MEMORANDUM

PROJECT: Frederick Road (MD355)/Brink Road Intersection Improvements

REVIEW TYPE: Mandatory Referral No. MR2009802

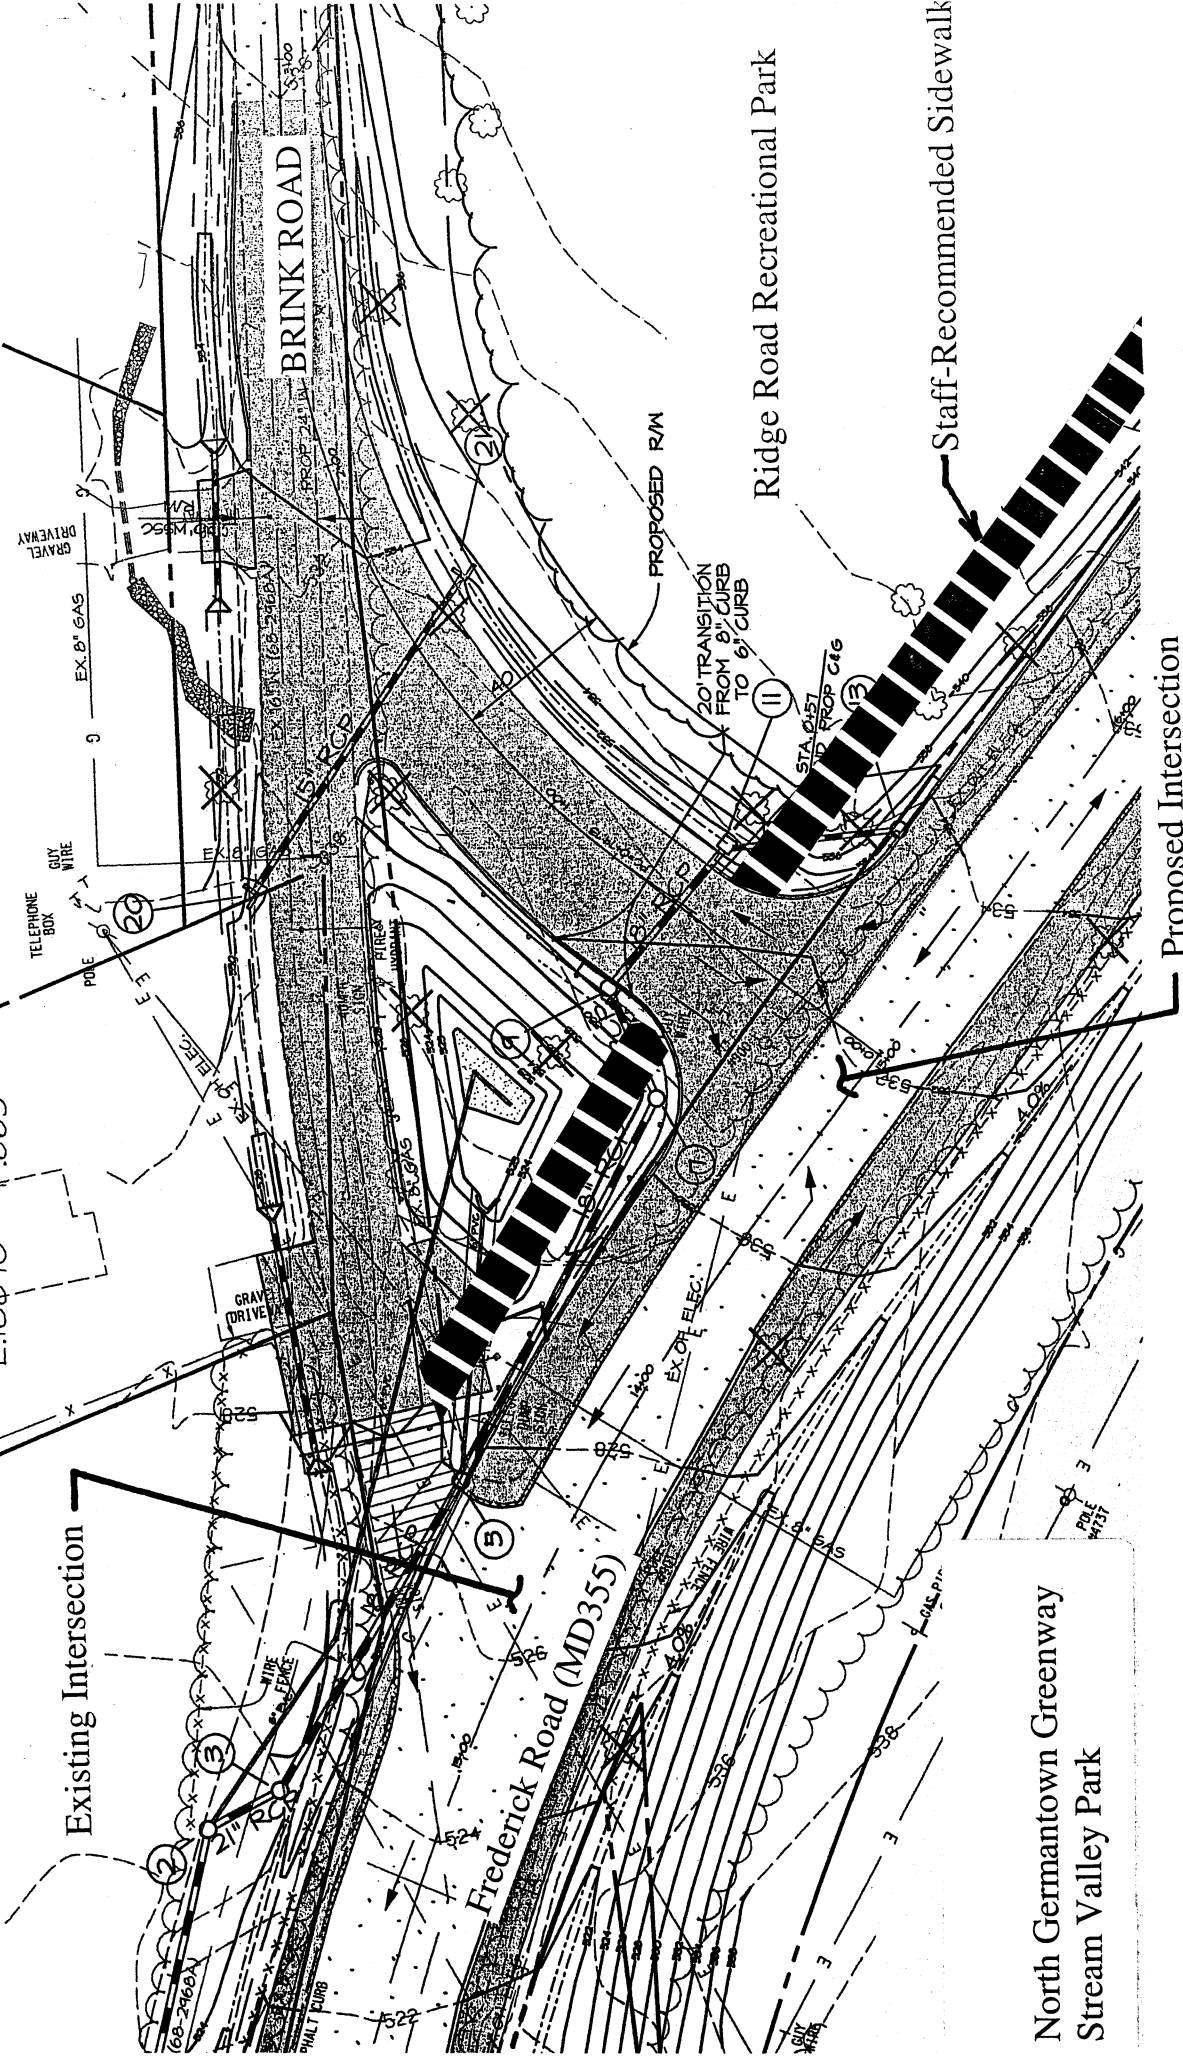
1. Improve the superelevation of the northbound travel lanes of MD355 in conjunction with the proposed intersection relocation and redesign.
2. Provide fourteen-foot-wide outside travel lanes.
3. Provide a five-foot-wide sidewalk on the east side of Frederick Road, separated from the curb by a nine-foot-wide landscape panel with street trees.

There is no standard for a four-lane Major Highway, but the new County Road Standard 2004.09 for a four-lane Divided Suburban Arterial Road requires a five-foot-wide sidewalk with a nine-foot-wide landscaped buffer. We recommend that sidewalks be constructed along the east side of Frederick Road and the north side of Brink Road. All sidewalks should be separated from the curb by a nine-foot-wide landscape panel and should extend through the limits of paving.

Staff-Recommended Sidewalk
